**MEMO**

**DATE:** August 16, 2013  
**TO:** Yakuh Askew  
**FROM:** Rick Cooper, Planning Department  
**RE:** PPA Case No. 2013.0813 for 5 Hallam Street

## Preliminary Project Assessment

*Date:* August 16, 2013  
*Case No.:* **2013.0813U**  
*Project Address:* 5 Hallam Street  
*Block/Lot:* 3755/096  
*Zoning:* Residential Enclave Use District  
Western SoMa Special Use District  
40-X Height and Bulk District  
*Area Plan:* Western SoMa Area Plan  
*Project Sponsor:* Yakuh Askew – (415) 920-1839  
*Staff Contact:* Wade Wietgreffe – (415) 575-9050  
[wade.wietgreffe@sfgov.org](mailto:wade.wietgreffe@sfgov.org)

Title: 5 Hallam Street (2013.0813U) Shadow Study  
 Comments: Analyzed for full lot coverage at 49 feet height.  
 Printed: 6 August, 2013

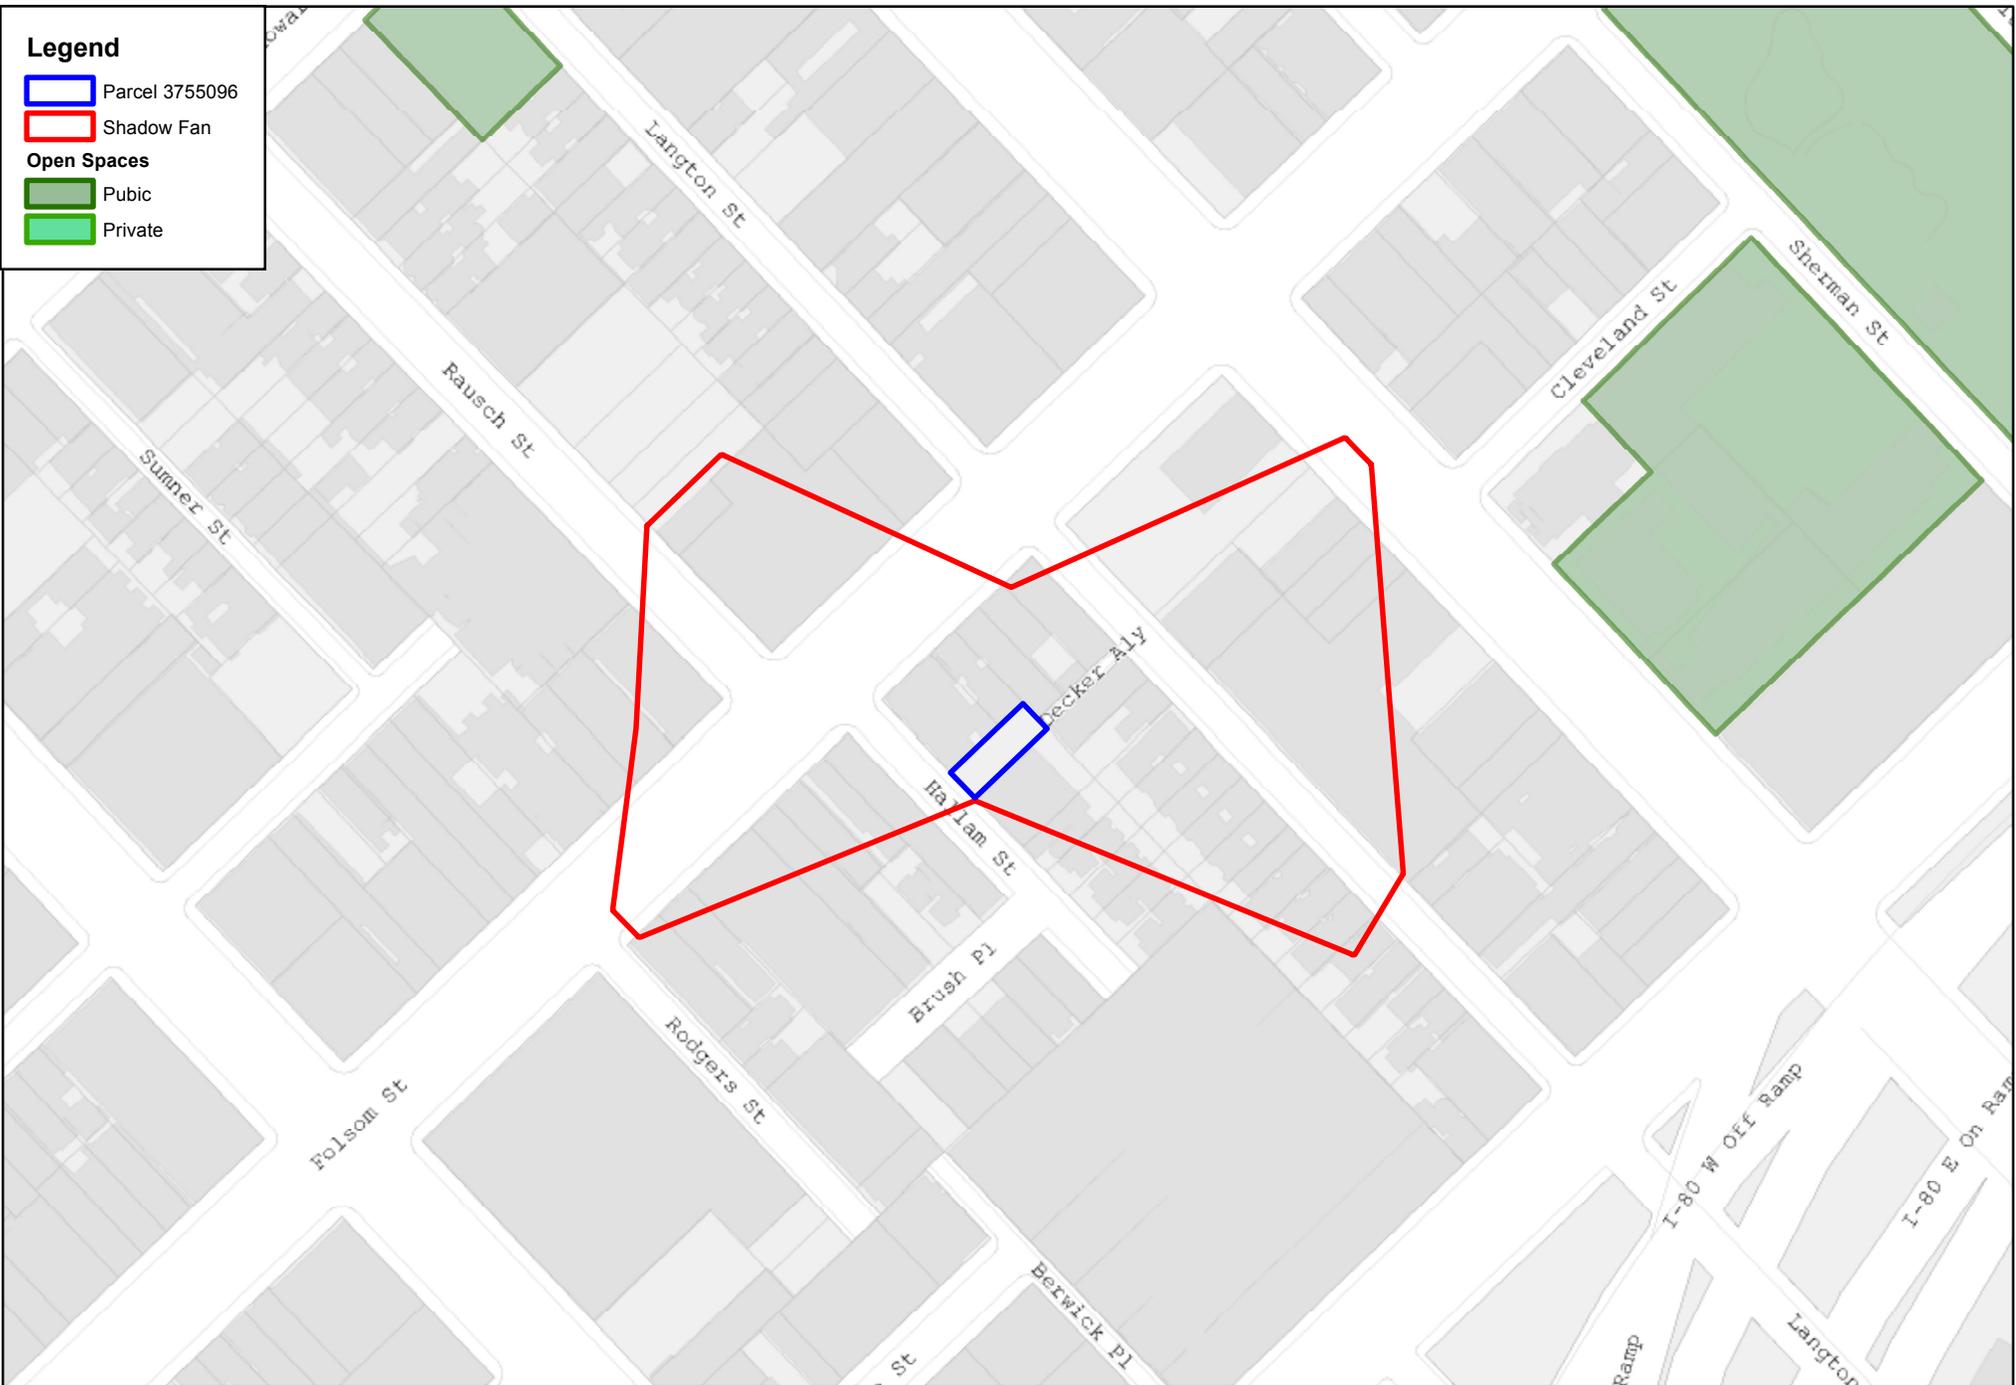
5. *Shadow.* The proposed project would result in construction of a building 40 feet in height (49 feet with penthouse). Planning Code Section 295 requires that a shadow analysis must be performed to determine whether a project has the potential to cast shadow on properties under the jurisdiction of the San Francisco Recreation and Park Commission. Department staff has prepared a shadow fan that indicates the project would not cast new shadow on any properties under the jurisdiction of the Recreation and Park Department, nor would it cast shadows on any other parks or open spaces (see attached).
